AEROPRAKT SERVICE BULLETIN

No. SB A32-22

WINDSHIELD GLASS REPLACEMENT ON A32 AND A32L AIRPLANES

Fig. 1

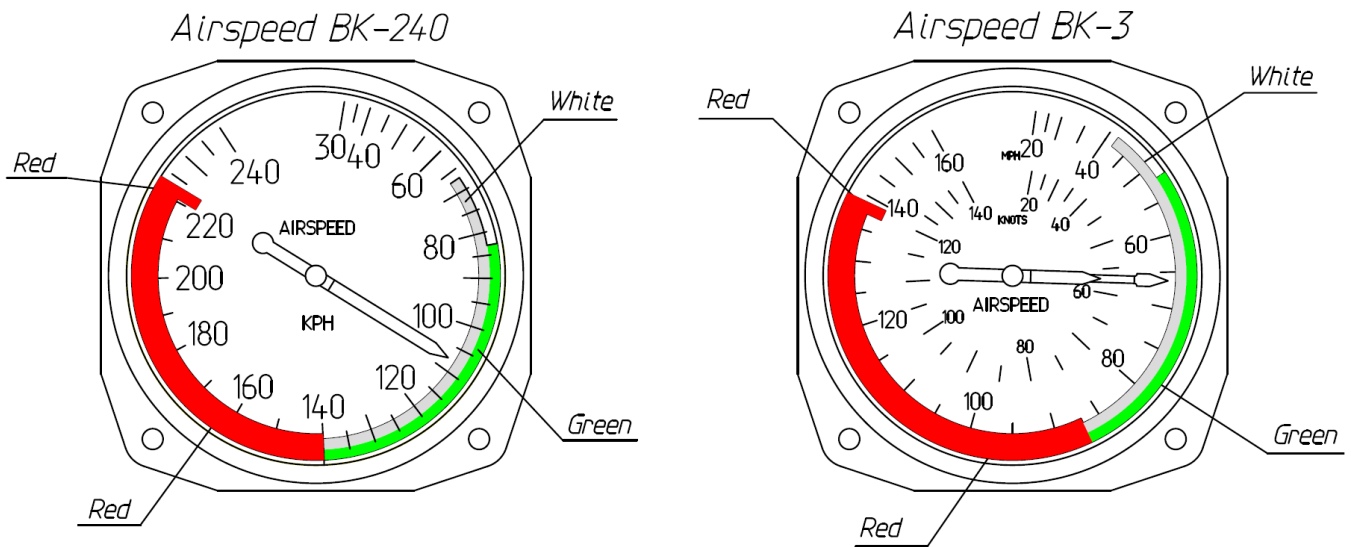
2.1) Before replacing the windshield, put a temporary red speed limit sector $V_{ne} = 140 \text{ km/h}$ (87 mph) to the airspeed indicator (see Fig. 1) and mark this temporary speed limitation in the relevant section of the POH (in any convenient way, for example, with a red pencil).
